SIB 52 10 22

RECALL 22V-942: CHECK THE DRIVERS SEAT BACKREST FRAME SCREWS

This Service Information Bulletin (Revision 1) replaces SI B52 10 22 **dated December 2022**.

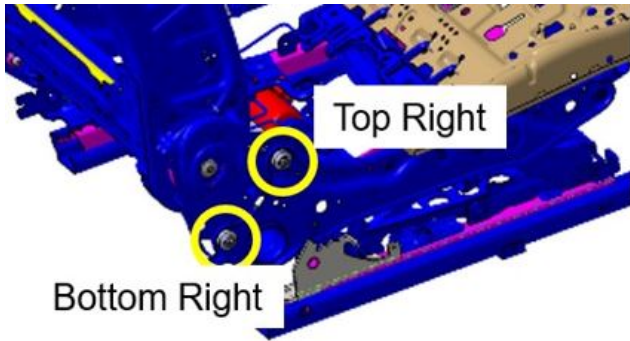
Check both outer seat backrest retainer screws. If the screw is found loose then it must be replaced (9908419 Countersunk screw - M10x16).

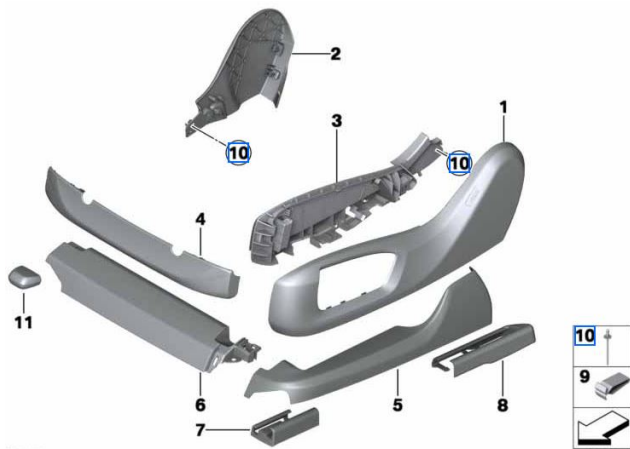
Check both inner seat backrest retainer screws. If the screw is found loose then it must be replaced (9908419 Countersunk screw - M10x16).

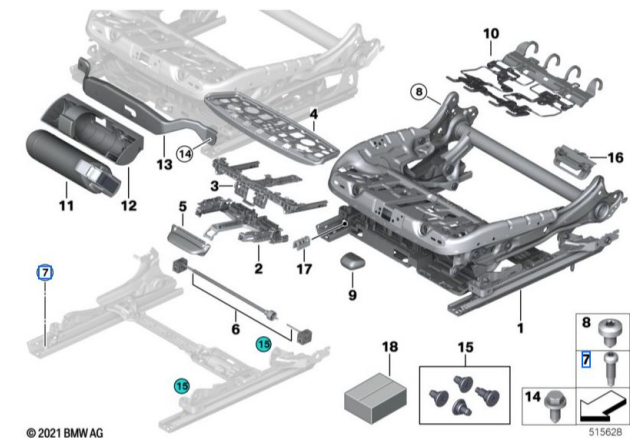
Seat plastic covers are held by blind rivets which may have to be replaced for access (7042164 blind rivet).

Seat rail mounting screws must be replaced once seat has been removed (9321690 Fillister head screw - Qty 4).

If the seat has been removed from the vehicle the safety belt mounting screw must be replaced (9909471 screw).
